ADVENT
VIDEOBEAM 1000A
SERVICE MANUAL CORRECTION SHEETS
(**FOR REPRINTED MANUAL OF 3/17/77)
(*FOR REPRINTED MANUAL OF 1/1/78)
(No Asterisk – Correction No. 1 After 1/1/78)

Please make the following changes to your service manual:

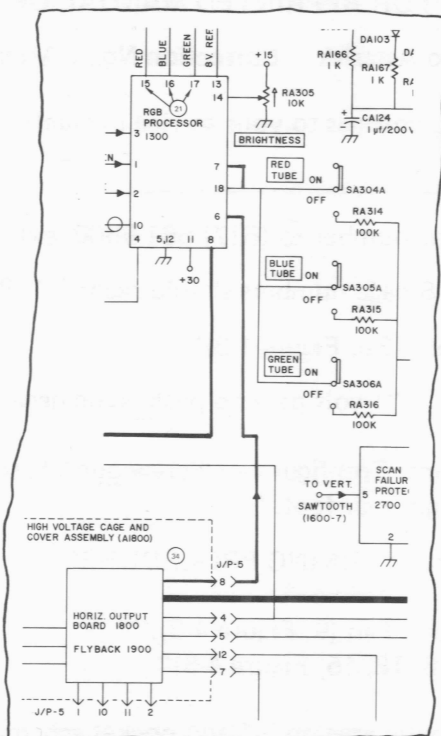
- 5-1 ** Waveform 24 refers to board 1600 pin 5, not pin 2.
- 5-1 ** Change schematic area on 5-1 and pocket schematic as follows:

Add a line from Board 1300 Pin 18 to Board 1300 Pin 7.
 Add a line from Board 1700 Pin 11 to Board 1300 Pin 8.
 Add a line from Junction/Plug 5 pin 8 to Board 1300 Pin 6.
 Delete a line from Junction/Plug 5 pin 8 to Center Tap of SA306A.

- 5-1 ** Change schematic area on 5-1 and pocket schematic as follows:

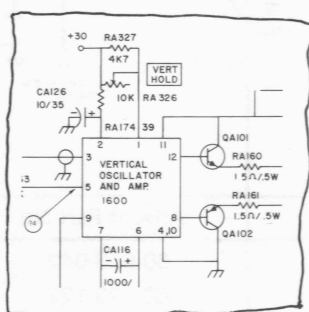
Add CA126 10 μ f/35V electrolytic with the following connections:
 Positive side (+) connected to Board 1600 Pin 2
 Negative side (-) connected to chassis ground.

Add RA174 39 Ω 1/4W 10% with the following connections:
 One end connected to Board 1600 Pin 2
 Other end connected to the 30V supply placing RA174 in series with the 30V supply.

5-4

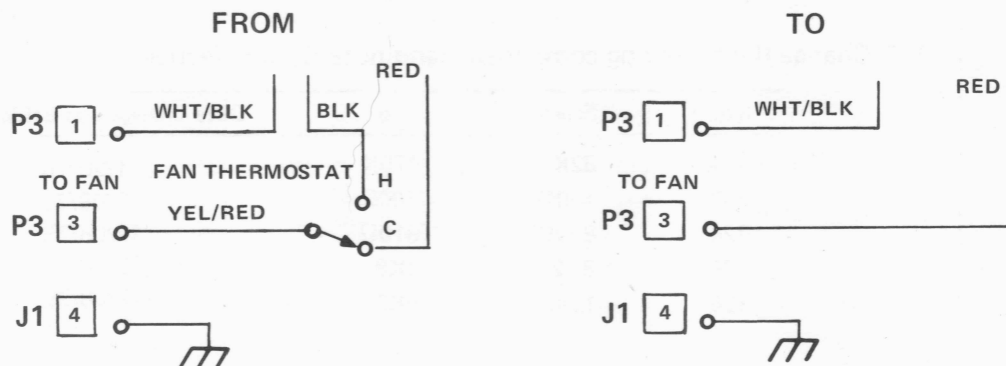
Delete the following component and note date effective:

Fan Thermostat; effective 2 months after start of 1000A production.

Change the following lines on the schematic drawing as shown:

5-4
and
5-4A

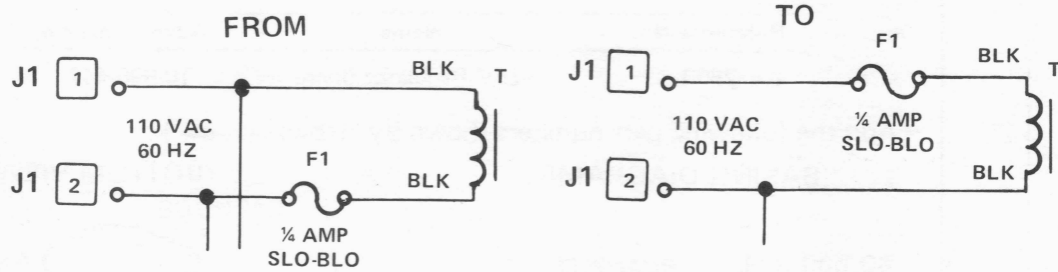
Change the position of the following component on schematic as shown and note date effective.

Fuse, F1, ¼AMP.-slow blow. Date effective 2/27/78.

5-6

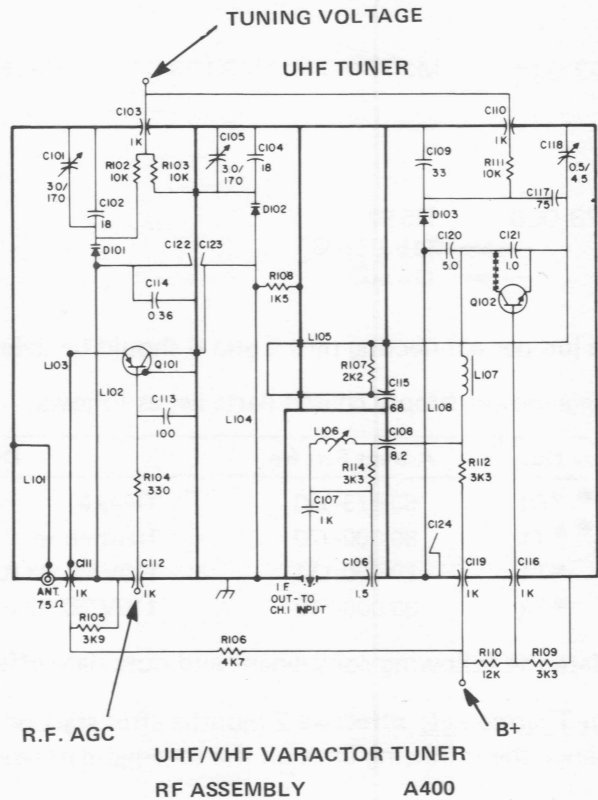
Add the notes shown by arrows:

5-19

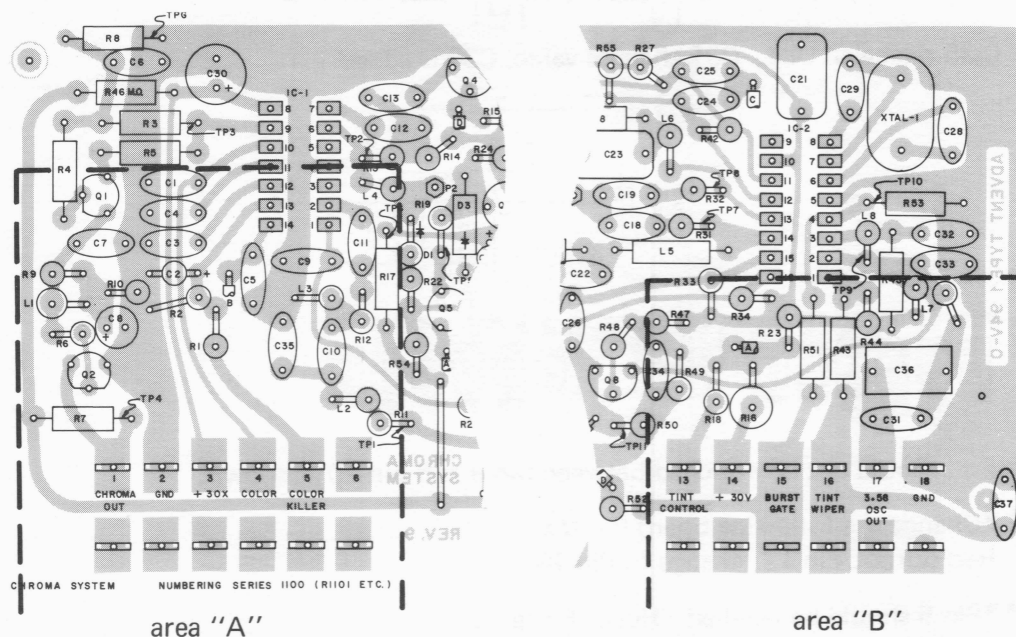
****New board assembly areas as shown:**

Changes in area "A" are as follows:
10K deleted. C5 and C9 relocated to component side of board.

Changes in area "B" are as follows:
C35 relabeled C37. C31 changes value. C36 is added.

IC2:

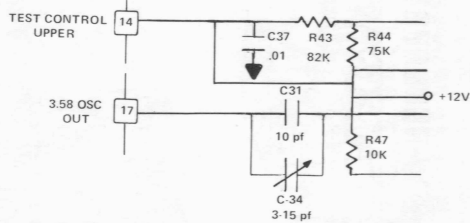
5-20 ** Change schematic area as shown:

5-20 ** C-35 relabeled C37. C31 changes value, C36 is added.

5-32

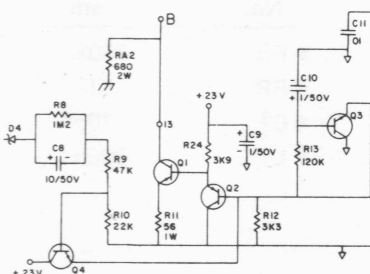
** Change the following components as follows:

** Delete diode D5

** Add Transistor Q4 as shown

* R21 from 82K to 75K Effective 11/12/75

* C4 from 0.39 to 0.33 Effective 3/17/76

Tripler-High Voltage Bleeder Assemblies

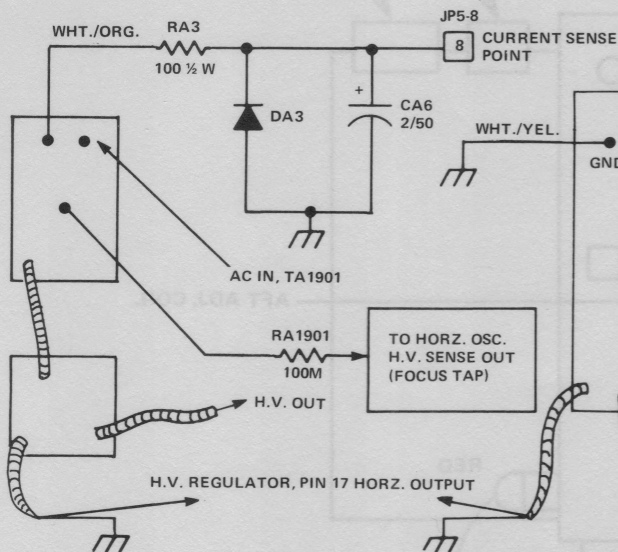
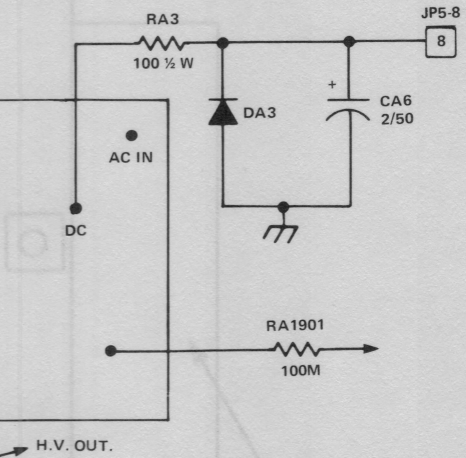
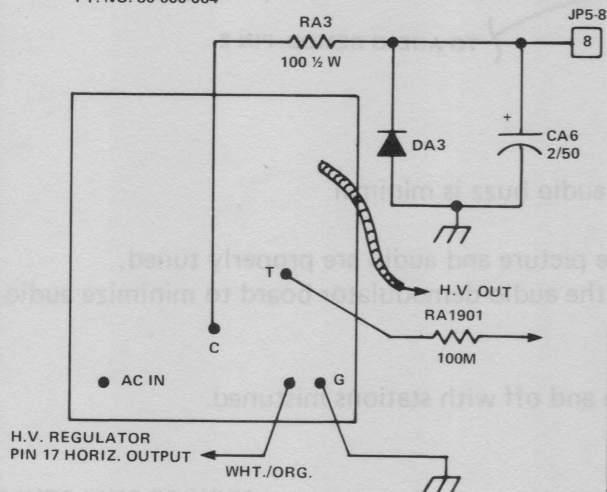
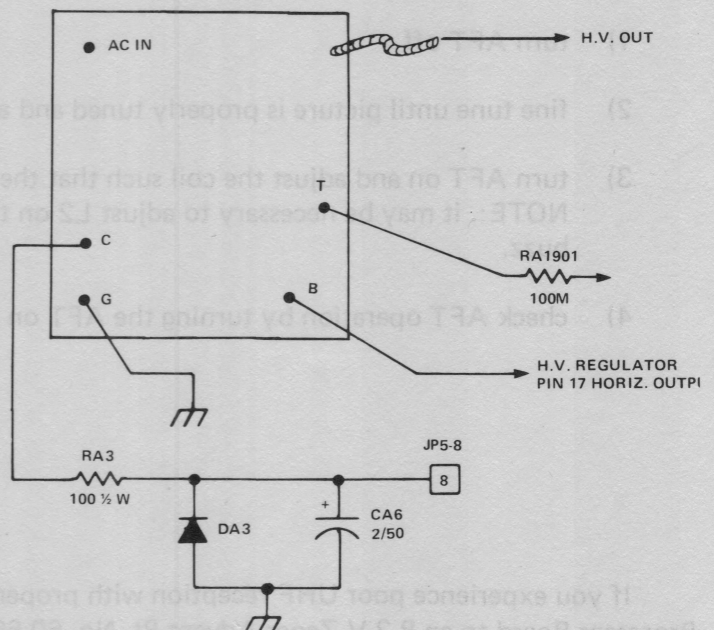
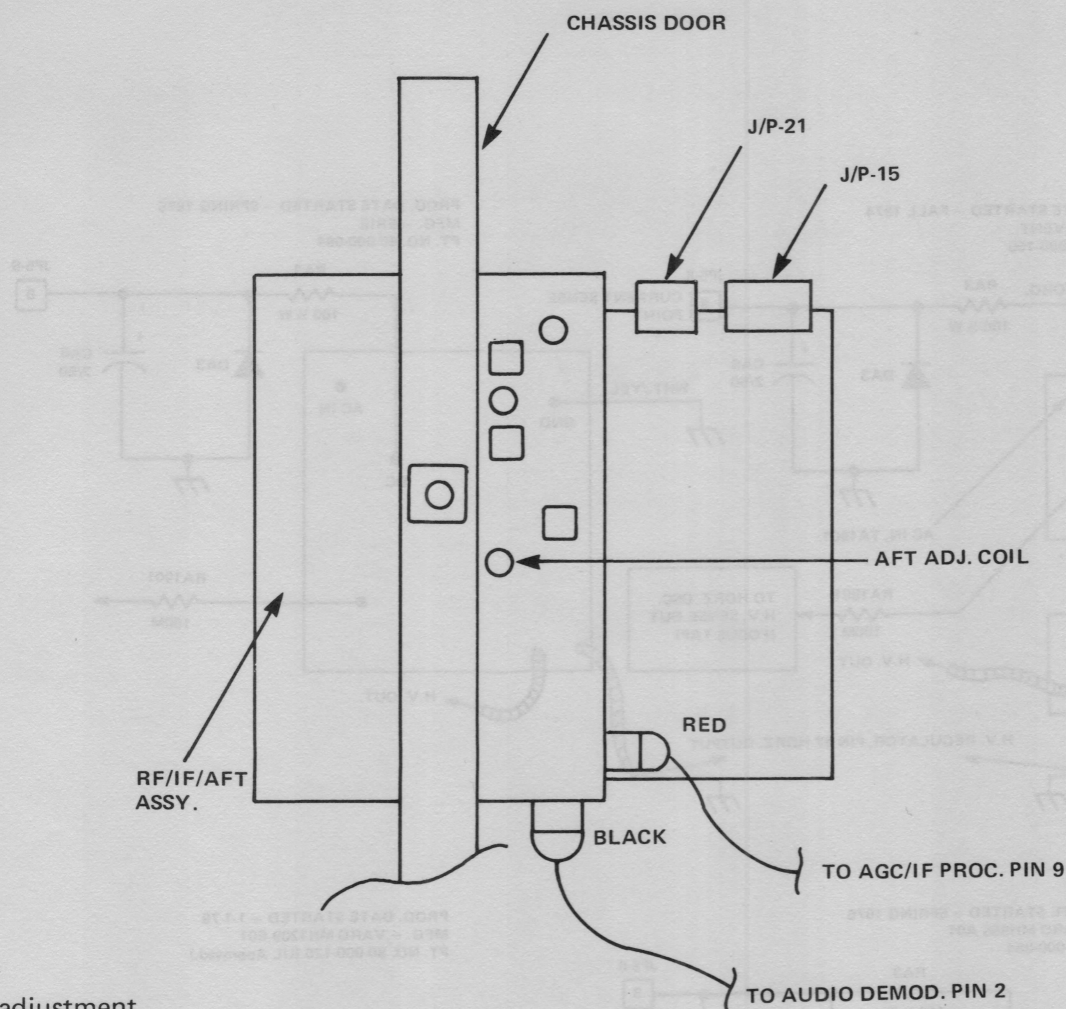
PROD. DATE STARTED - FALL 1974
MFG. - ADVENT
PT. NO. 10-990-155

PROD. DATE STARTED - SPRING 1975
MFG. - ERIE
PT. NO. 80-000-064

PROD. DATE STARTED - SPRING 1976
MFG. - VARO MH965 A01
PT. NO. 80-000-064

PROD. DATE STARTED - 1-1-78
MFG. - VARO MH1209 E01
PT. NO. 80-000-120 (UL Approved.)

AFT adjustment

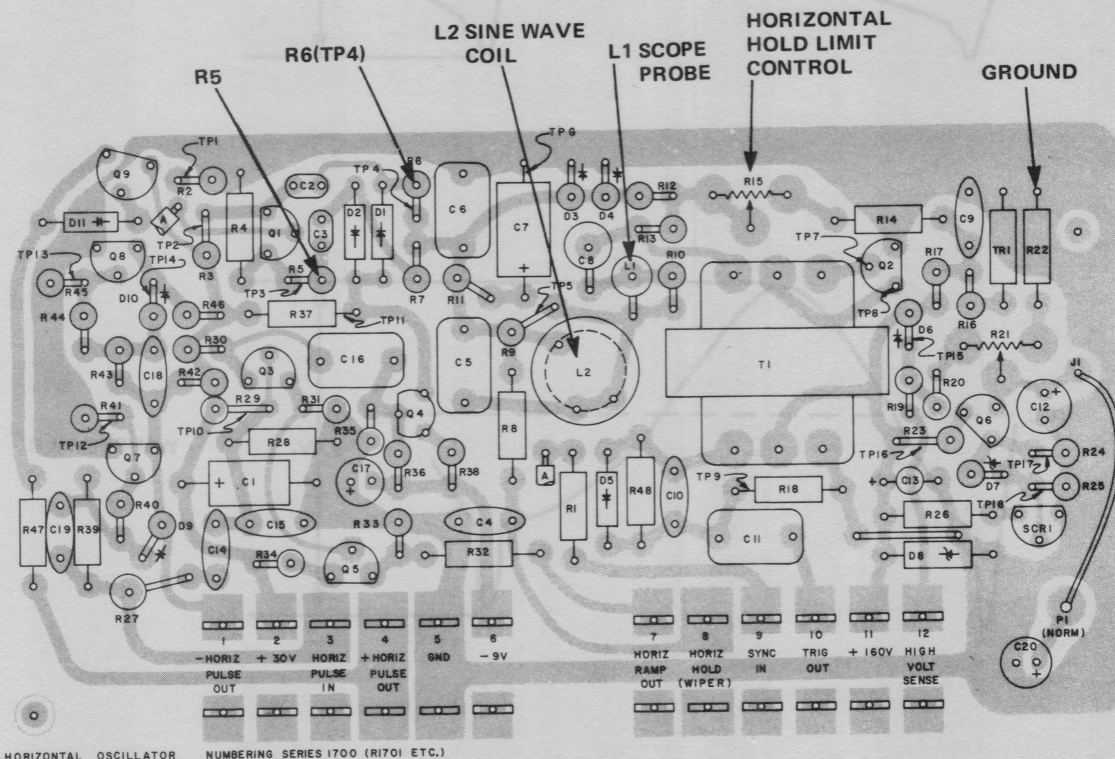
- 1) turn AFT off
- 2) fine tune until picture is properly tuned and audio buzz is minimal
- 3) turn AFT on and adjust the coil such that the picture and audio are properly tuned.
NOTE: it may be necessary to adjust L2 on the audio demodulator board to minimize audio buzz.
- 4) check AFT operation by turning the AFT on and off with stations mistuned.

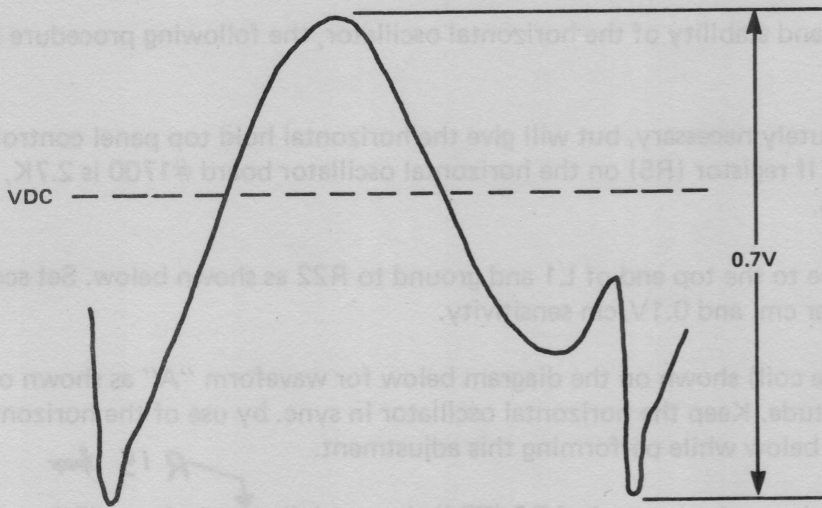
If you experience poor UHF reception with proper signal level change zener diode D5 on the AGC/IF Processor Board to an 8.2 V Zener Advent Pt. No. 60-663-017 (1N5237A).

SERVICE BULLETIN NO. 4
Horizontal Oscillator Adjustment

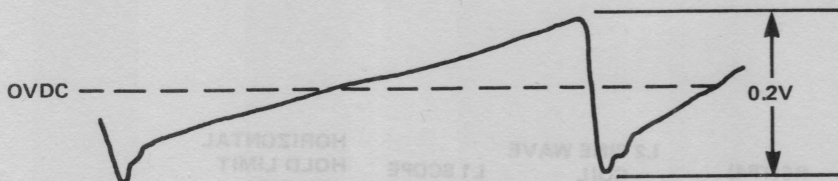
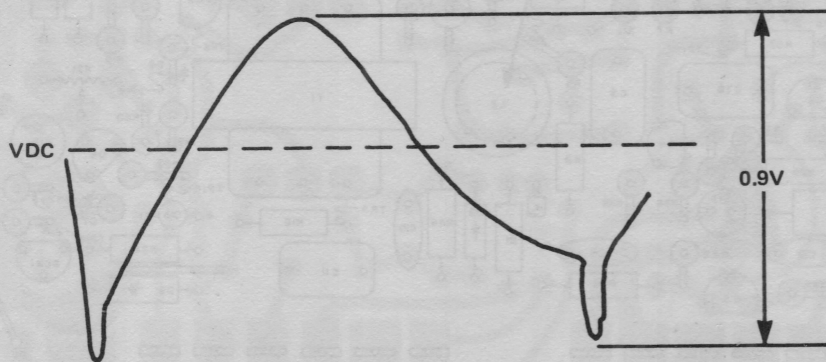
1. Step #1 is not absolutely necessary, but will give the horizontal hold top panel control symmetry in frequency range. If resistor (R5) on the horizontal oscillator board #1700 is 2.7K, replace it with a 1K8 ¼W 10%.
2. Attach a scope probe to the top end of L1 and ground to R22 as shown below. Set scope sweep to 10u sec. per cm. and 0.1V/cm sensitivity.
3. Adjust L2 (sine wave coil) shown on the diagram below for waveform "A" as shown on page 3 with proper amplitude. Keep the horizontal oscillator in sync. by use of the horizontal hold limit control shown below while performing this adjustment.
4. Attach the scope probe to the top end of R6 (TP4) shown. Adjust waveform "B," as shown to 0 VDC \pm 0.1 V by DC coupling the scope input.

Waveform "C" is shown as the most unstable and incorrect waveform. To go from waveform "C" to waveform "A" you would have to rotate the L2 slug in a clockwise direction.
